ADDENDA – A-01

.1 Bids in accordance with the Drawings and Specifications included with these Bid Documents for:
Fort St. John Hospital – Residential Care Cooling Upgrade.

PROJECT:
**FORT ST. JOHN HOSPITAL
RESIDENTIAL CARE COOLING
UPGRADE**

1 HOUSE B - LEVEL 1 PART PLAN
E101 1:100

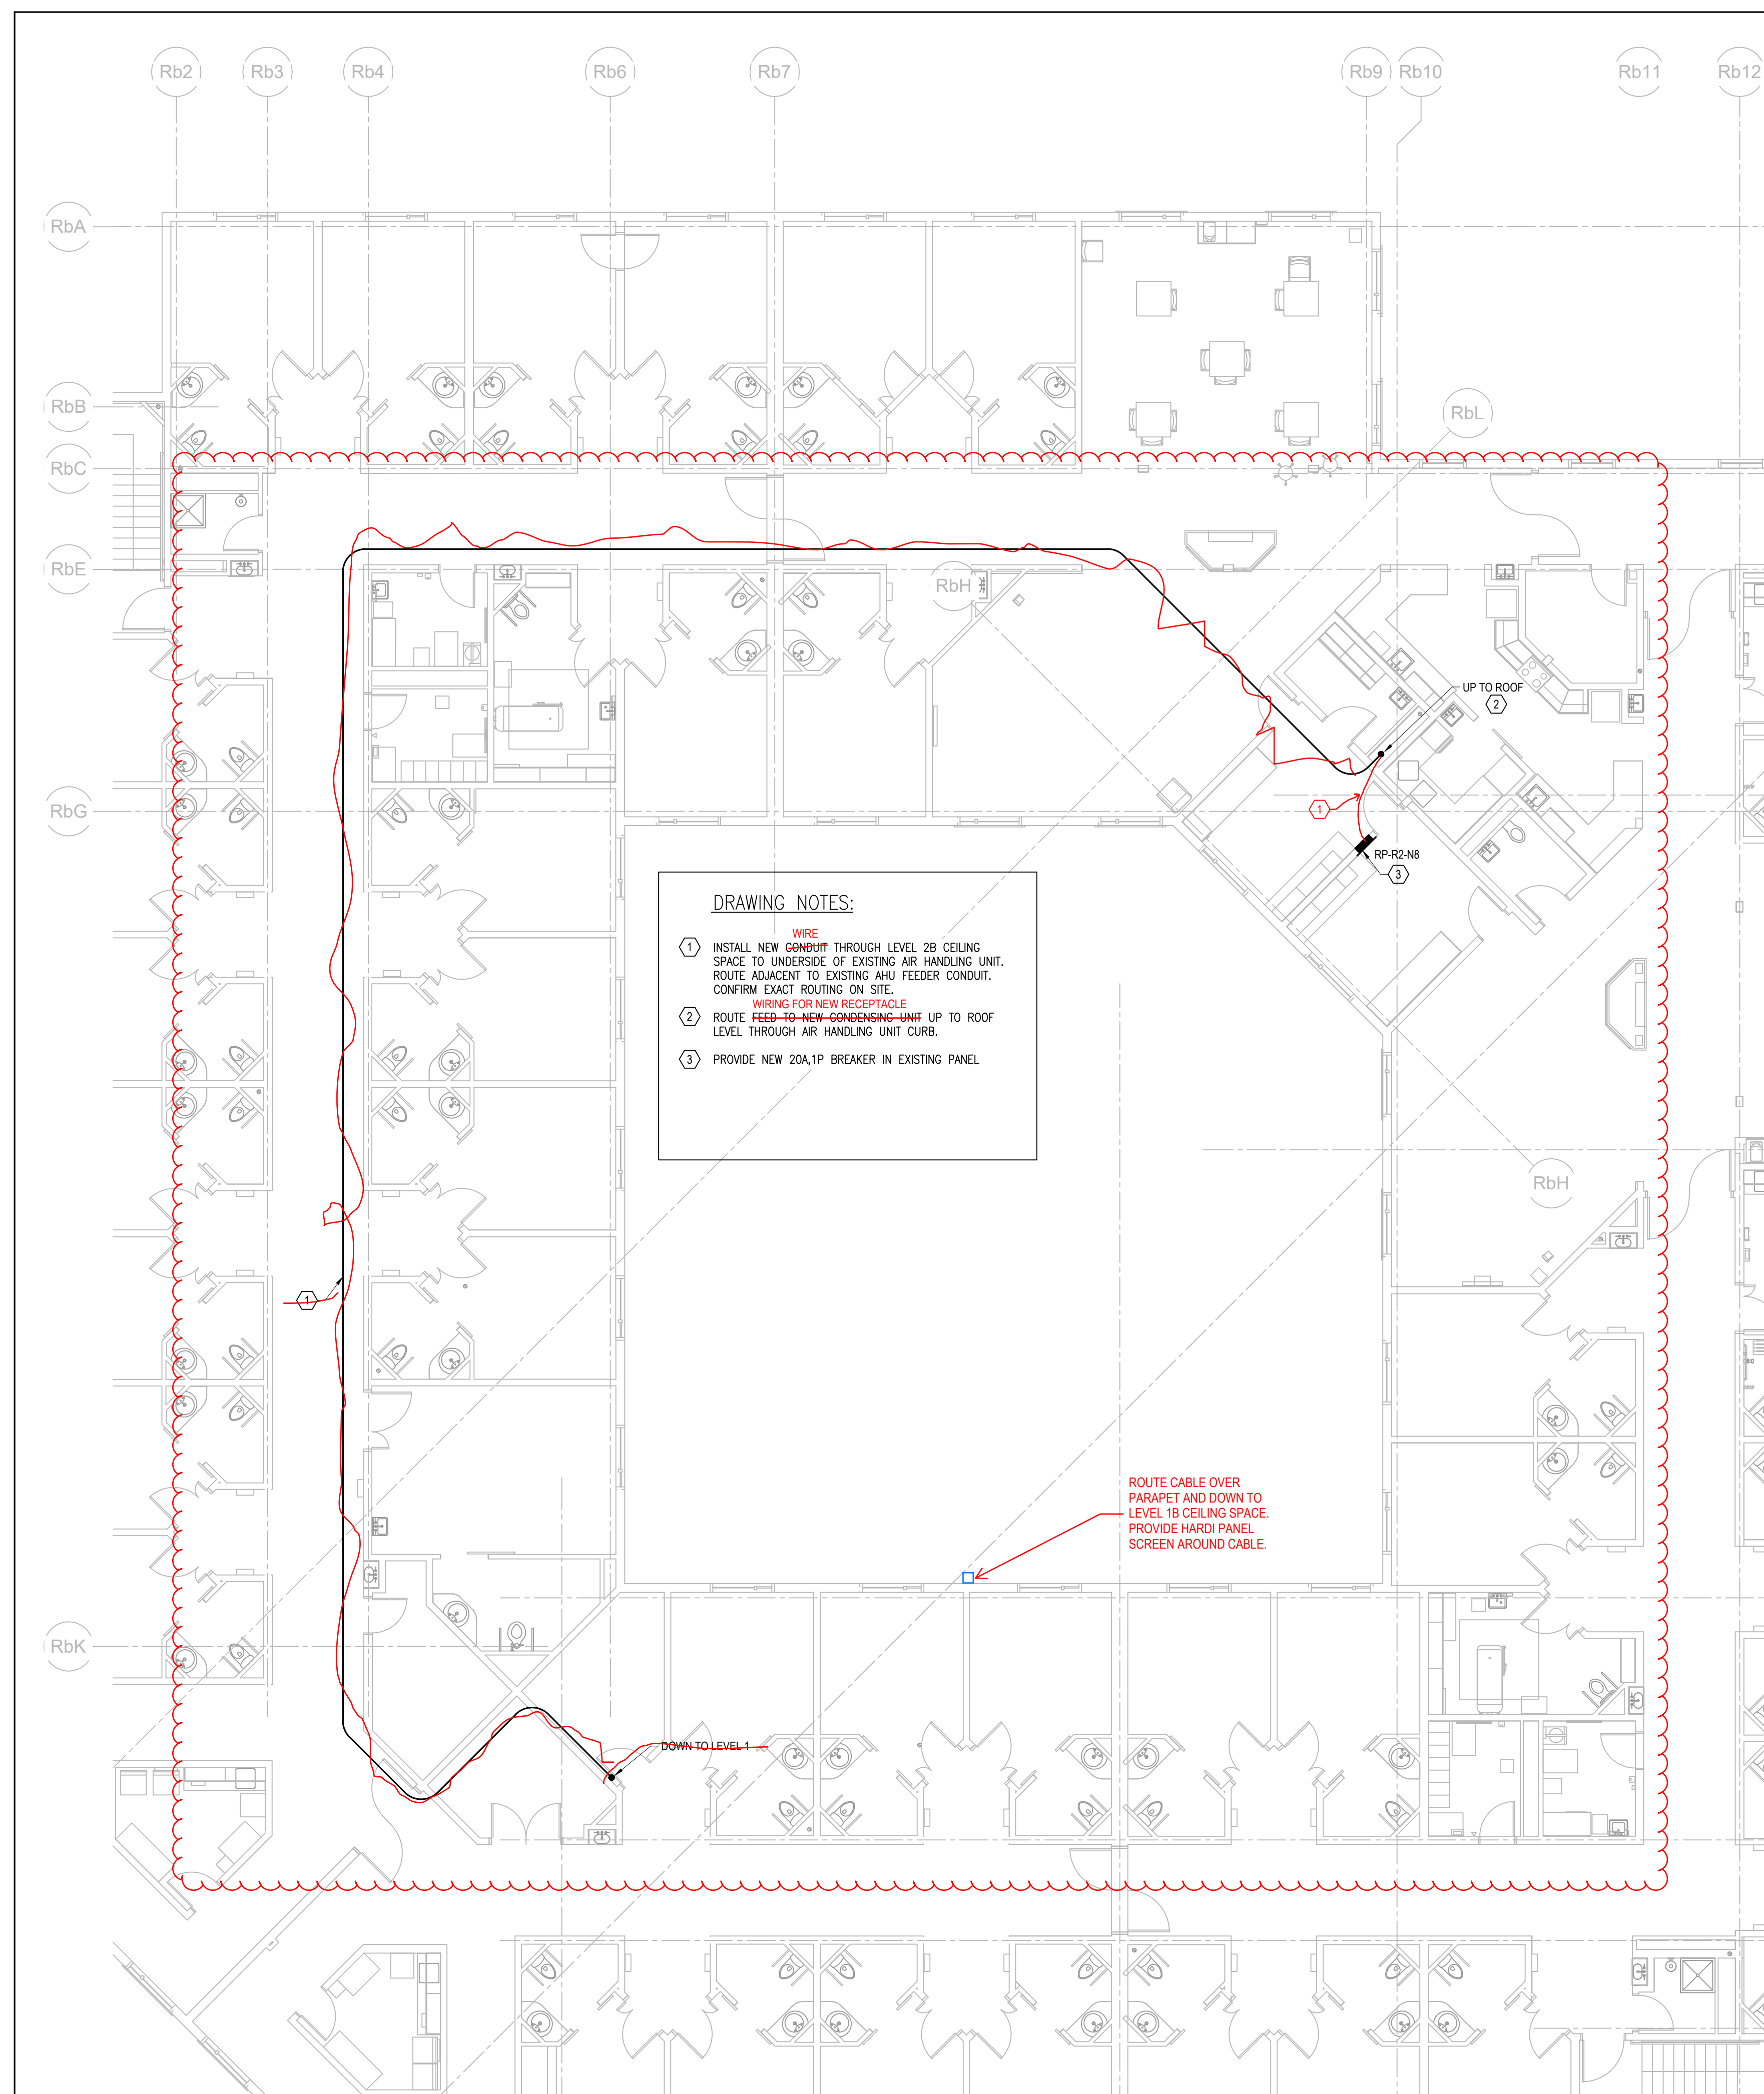
2.5 E101 – ELECTRICAL PART PLANS HOUSE B LEVELS 1, 2B, & ROOF

.1 Revised approach to new wiring approach as shown.

3 ELECTRICAL FEEDER ROUTING**3.1 Description of Revised Approach**

- .1 The electrical feeder routing to the new condenser units in House A and House B has been revised to route exterior to the building, refer to the updated electrical drawings.
- .2 Exterior electrical feeders to be rated for outdoor installation and extreme environments, see “TECK90 – Aluminum Conductor” product datasheet included.
- .3 Exterior electrical feeders to be in an enclosure fastened securely to the building with Hardi plank finishing to match the building and minimize visual impact.
- .4 Electrical feeders shall not be exposed in the courtyard or accessible to patients or visitors in any way.

HHA PROJECT NUMBER: 2230541
DRAWING TITLE:
BUILDING A - ROOF LEVEL - NEW

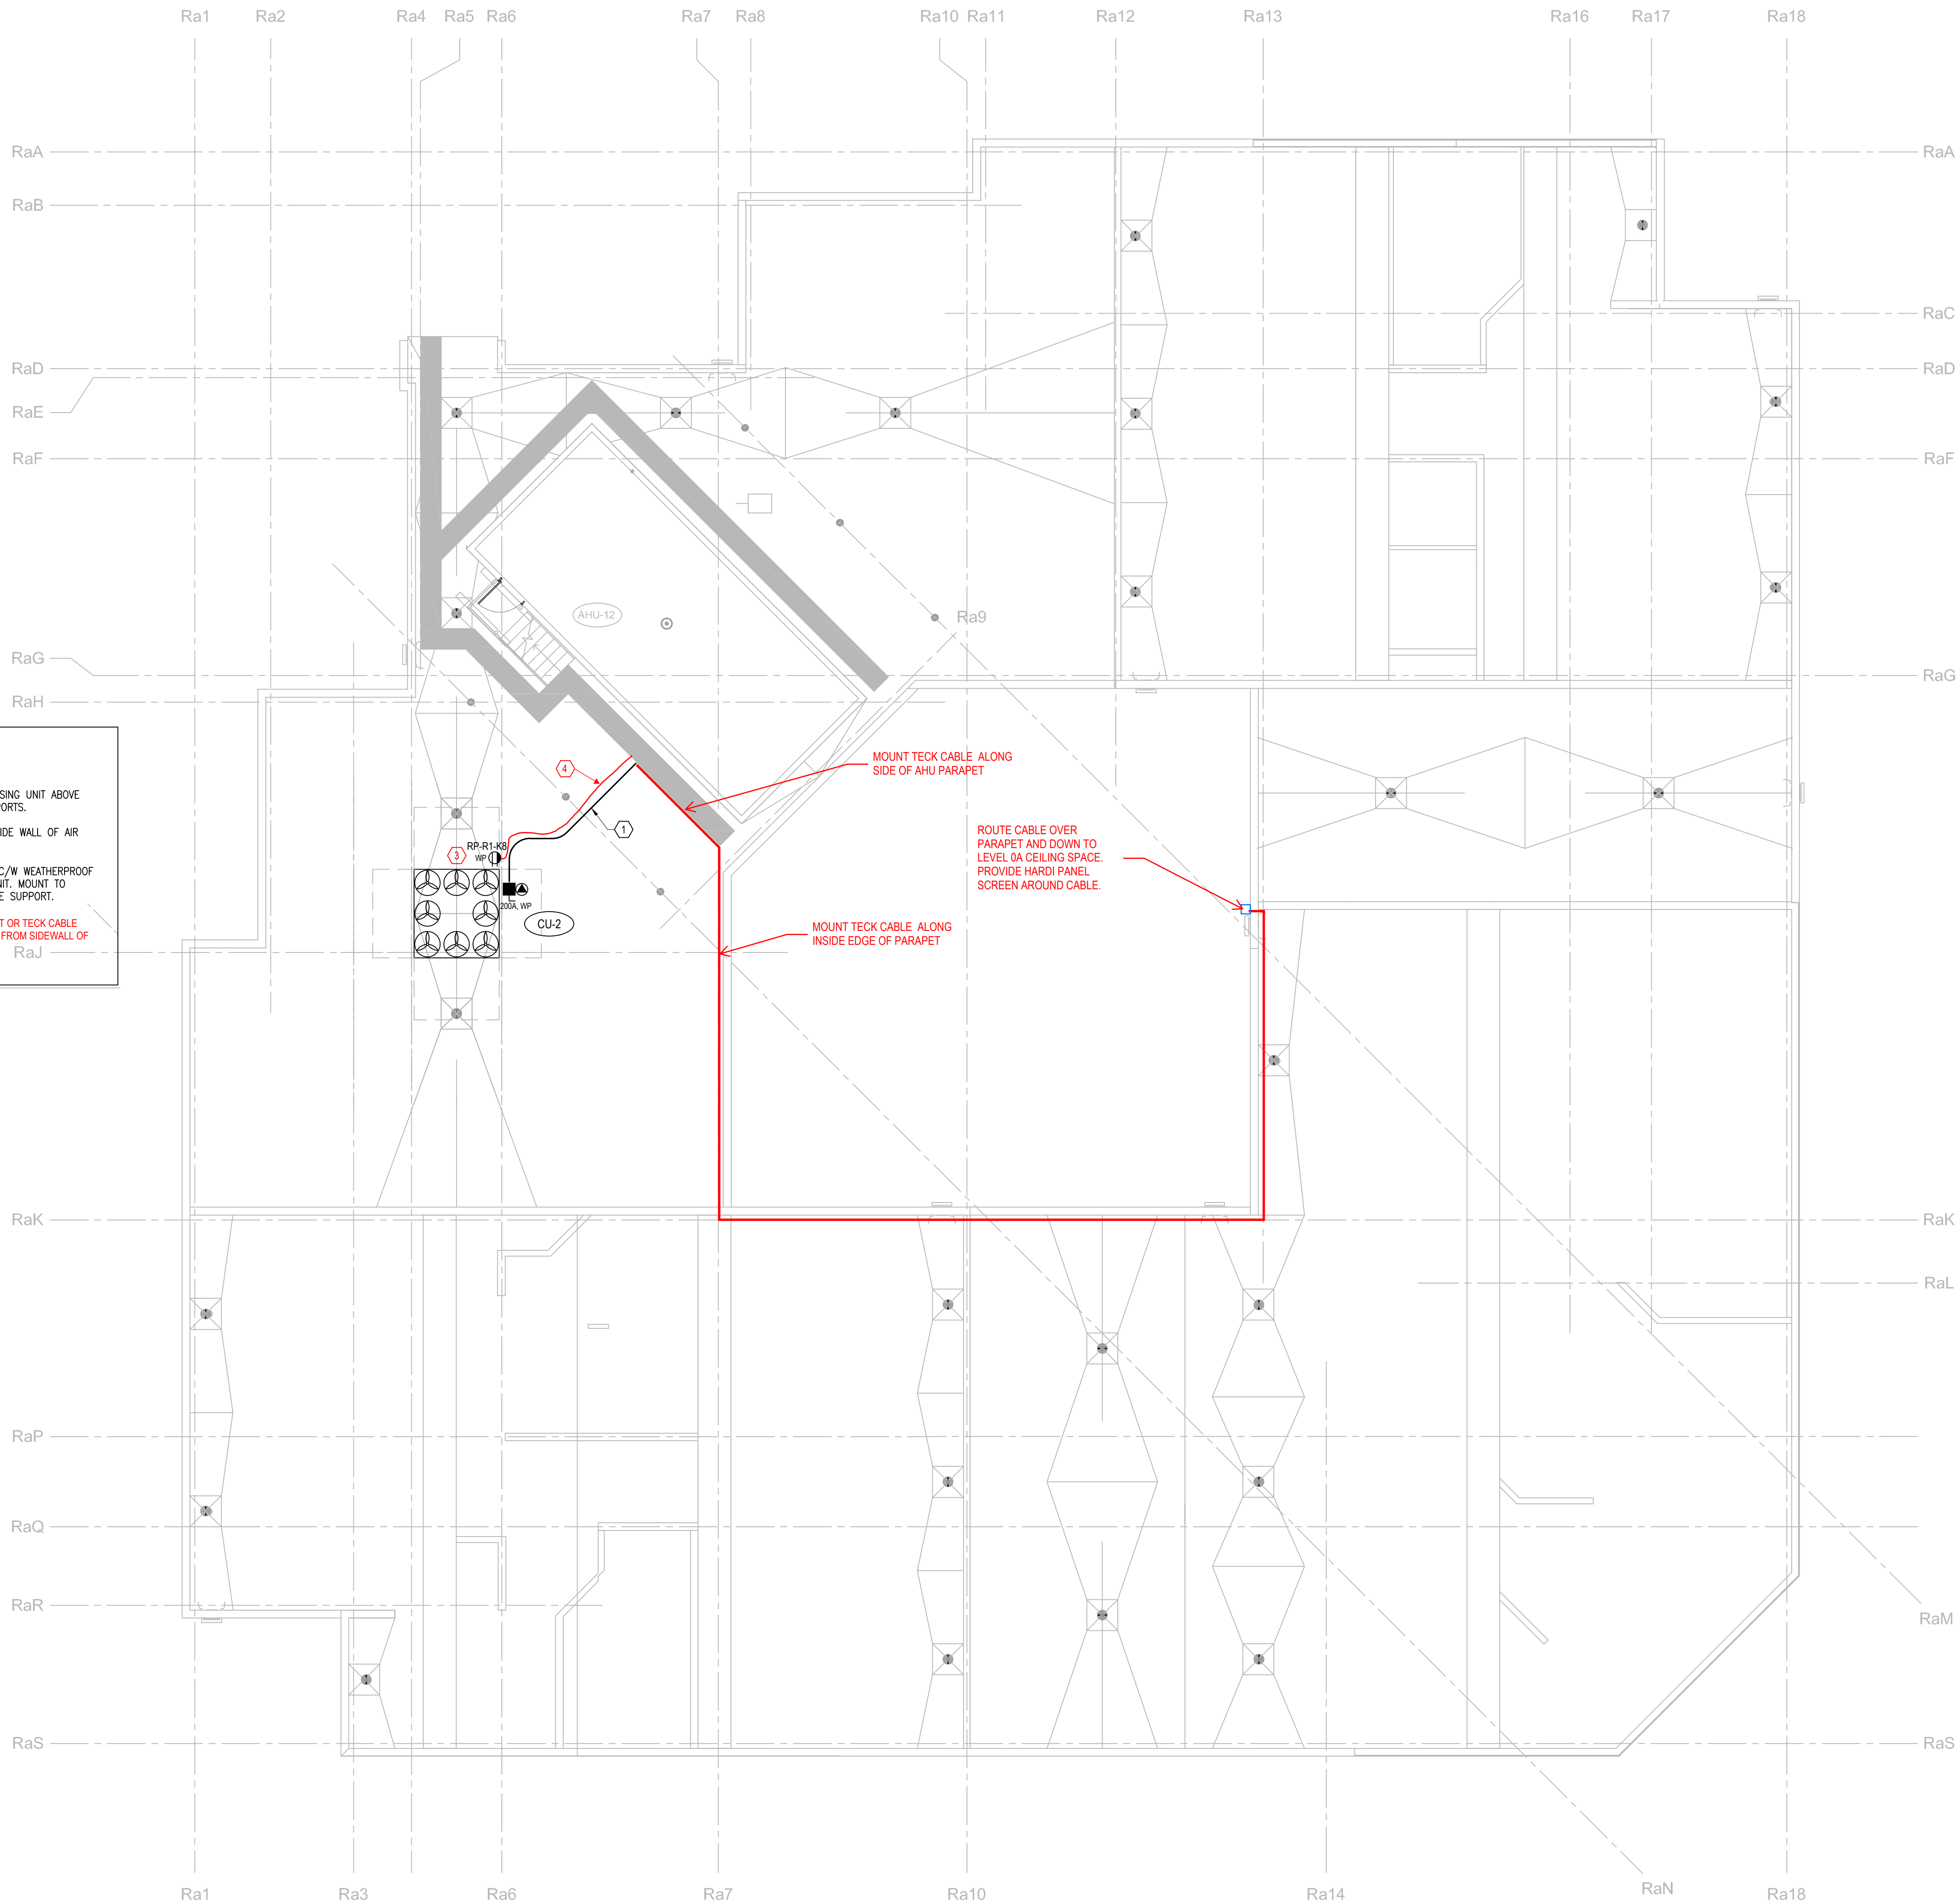
2.6 E102 – BUILDING A – ROOF LEVEL – NEW

.1 Drawing added to show scope of work on the roof.

H/A PROJECT NUMBER: 2230541
DRAWING TITLE:
BUILDING B - ROOF LEVEL - NEW

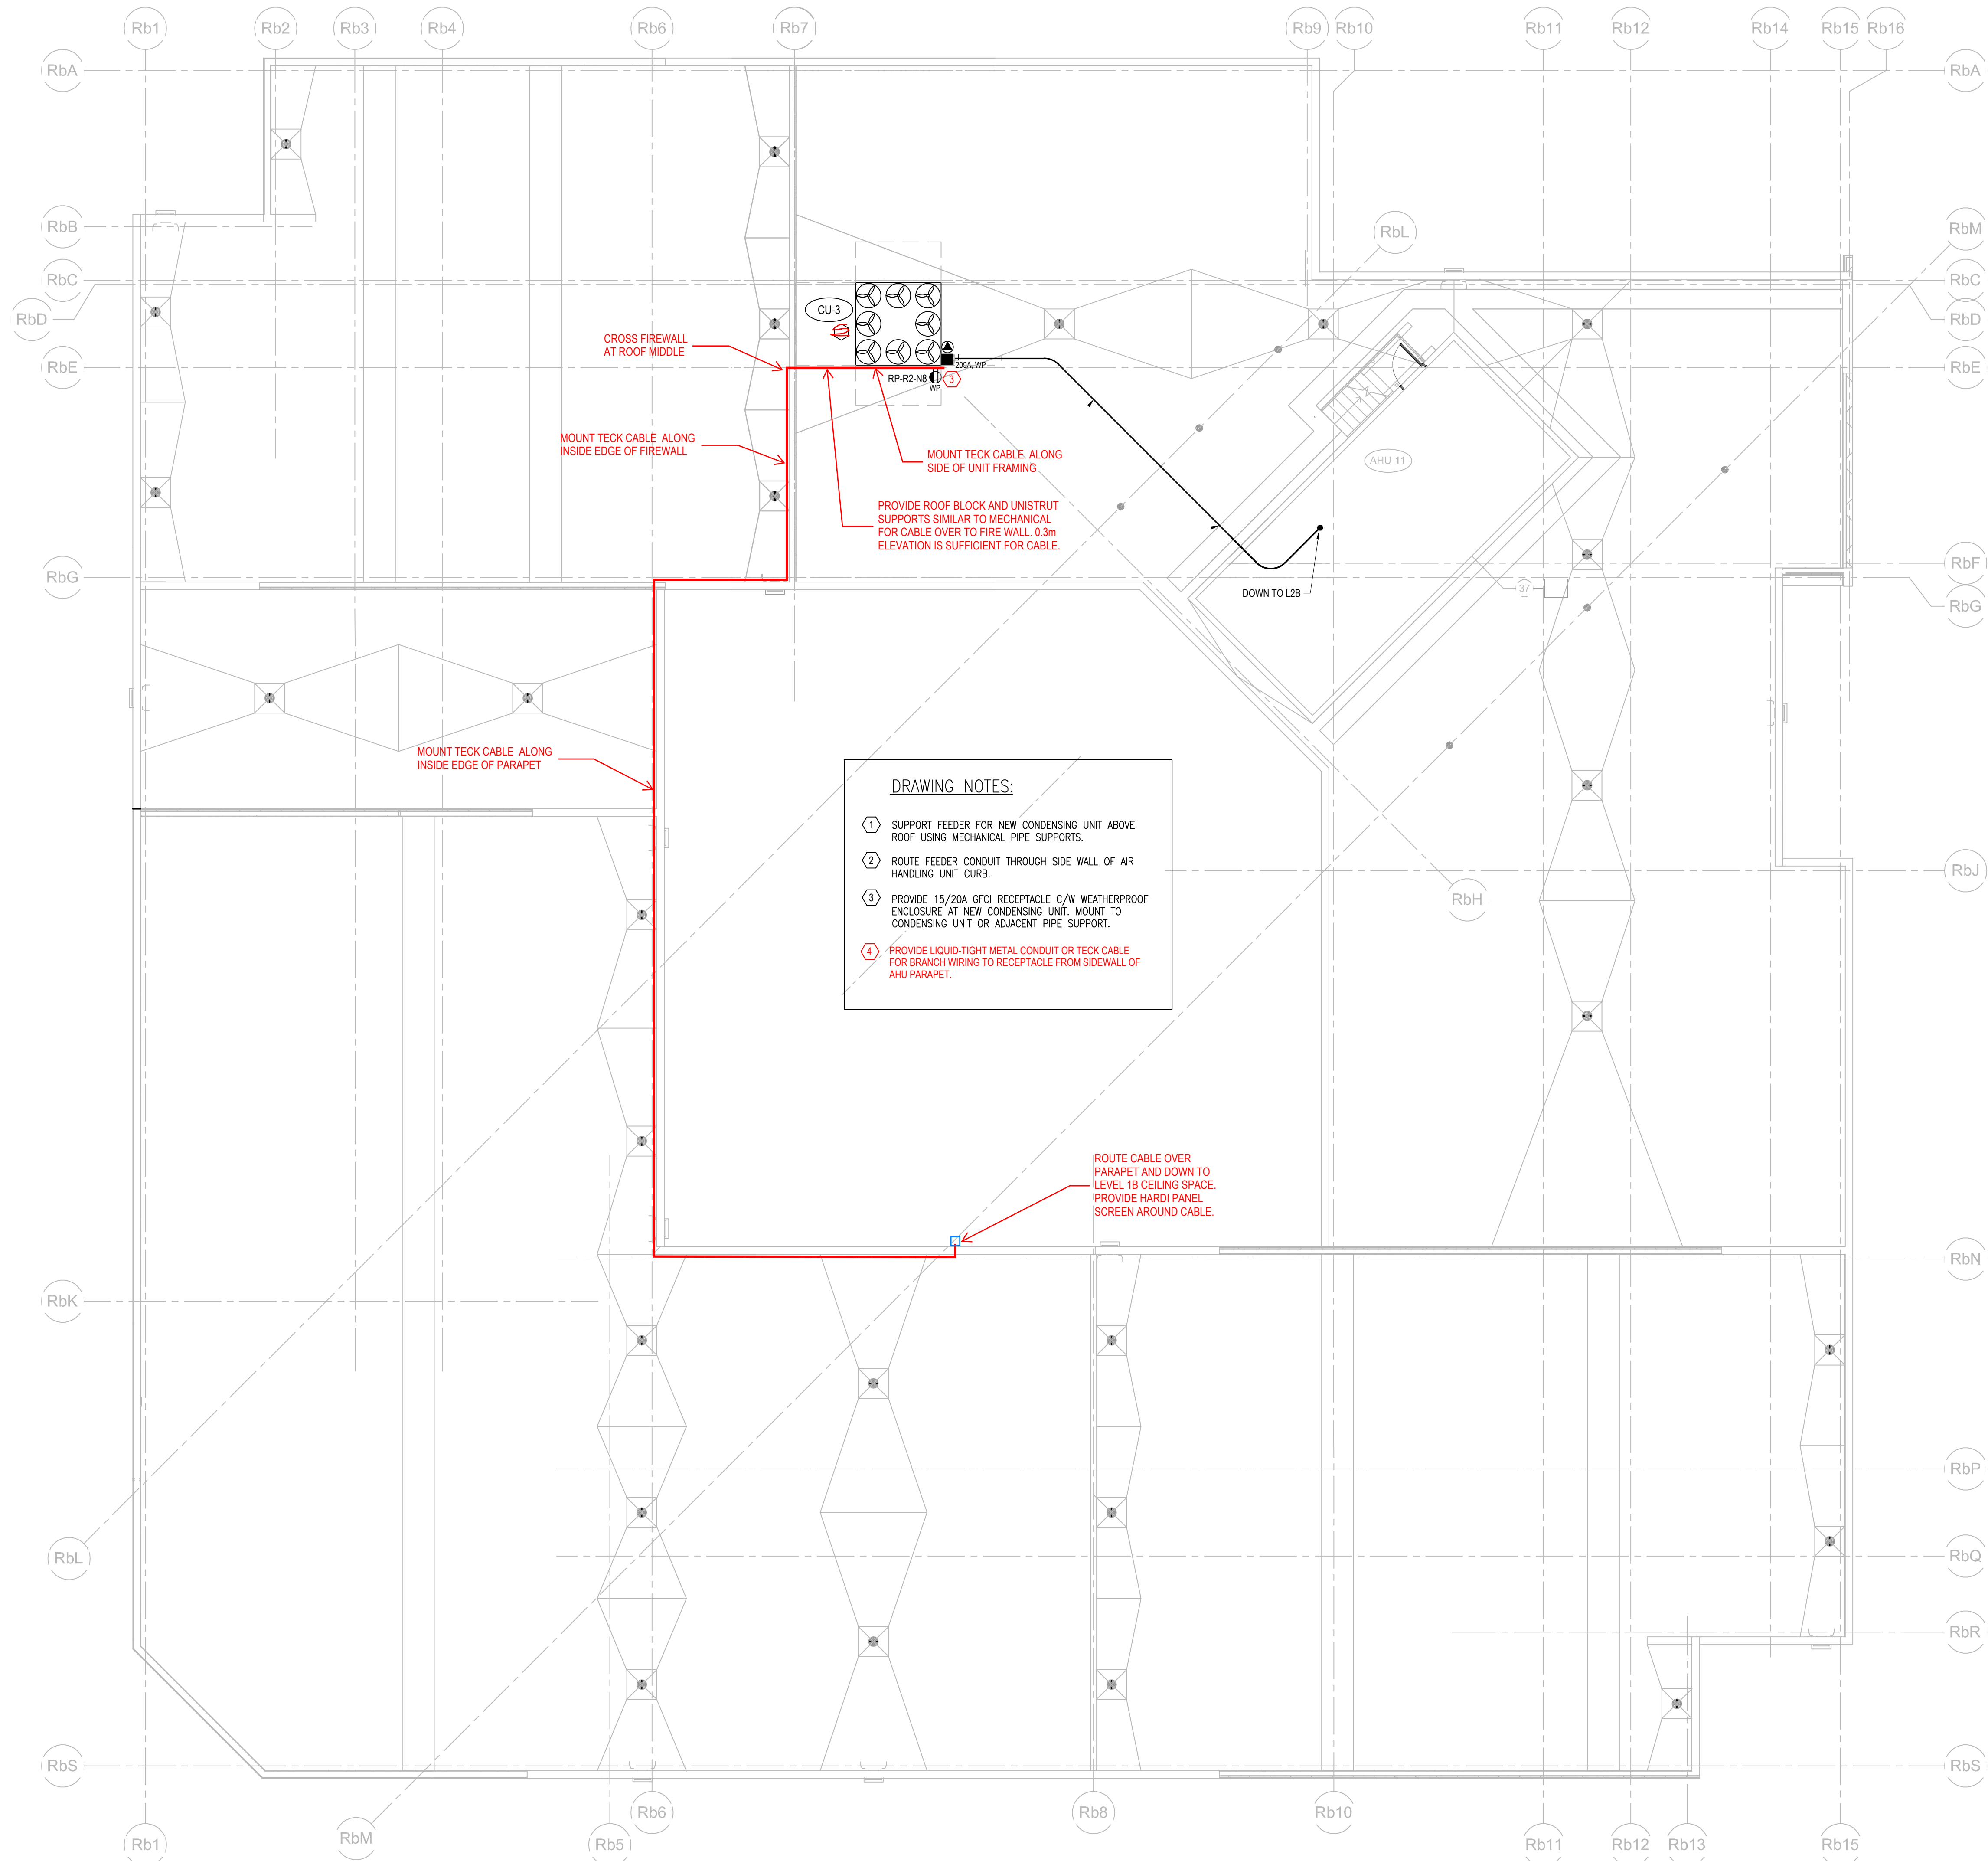
2.7 E103 – BUILDING B – ROOF LEVEL – NEW

- .1 Drawing added to show scope of work on the roof.
